No. RK/FCA/_____ <u>S 48</u> Forest Department, Himachal Pradesh

Diversion of 4.9069 ha. of forest land in favour of M/s Cliff Finvest Private
Limited 1-41 DFL Industrial area Phase-I Faridabad, Haryana-121003, for the
construction of Thaltukhod state-I SHEP (5.00 MW), within the jurisdiction of

Kindly refer to EDS dated 22.02.2025 of Nodal officer whereby following observations (EDS) raised and reply of the same is furnished as under:-

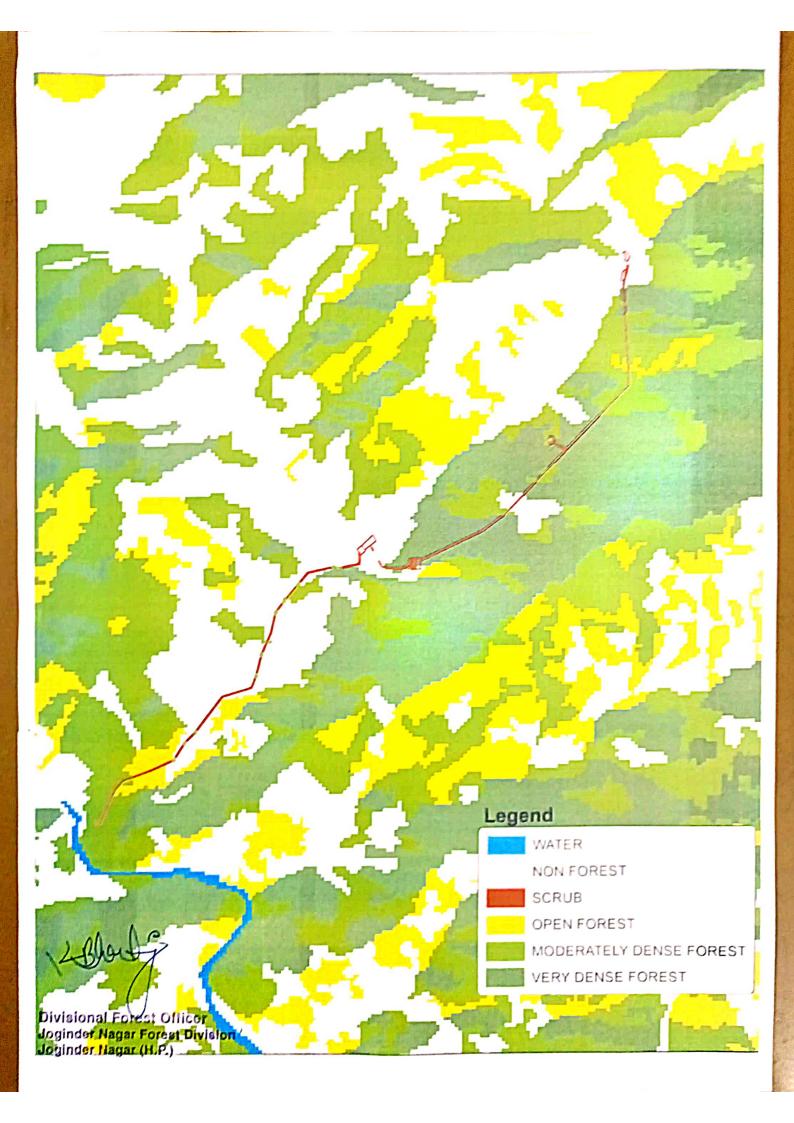
2.	Has the revised diverted area checked through DSS analysis.	The revised diverted area checked through DSS analysis and DSS analysis report enclosed herewith.

3.	Revised CA area is on steep slope. pl. check the slope.	The slope of the area checked and found that the slope of CA area is approximately 60 ° and the site is suitable for plantation.
